Office Action Summary**Application No.**

10/522,860

DETAILED ACTION

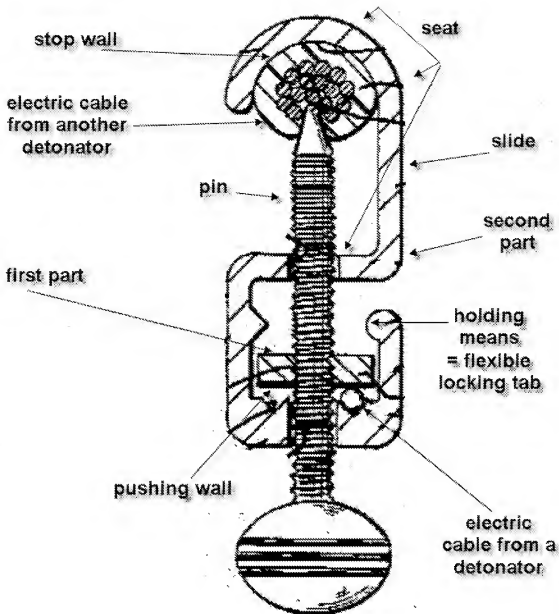
9. In regard to claims 2-6 and the electrical cable connector of claim 1, Manual Technico and Wilson as applied above disclose the claimed invention, but do not disclose an end connector as claimed. Holtzapple discloses an end connector for use in a pyrotechnical firing installation, labeled in a diagram on the next page, containing the following elements:

10. a first part solid with the end of an electrical cable which electrical cable comes from a detonator, the first part provided laterally with a connection pin to penetrate, in use, into the inside of an electrical cable coming from another detonator, and on the opposite side to the pins a pushing wall, and

11. a second part comprising a slide and a stop wall, into which the first part is mounted movable in relation to the stop wall which faces the connection pins, the wall and the slide defining a seat suitable for receiving an electrical cable oriented transversely to the electrical cable equipped with the connector.

13. In regard to claim 3, Holtzapple discloses that the slide comprises lateral walls, perpendicular to the stop wall, of which at least one of the lateral walls comprises on its outside a

holding means of the first part provided with a flexible locking tab approximately perpendicular to the pushing surface.
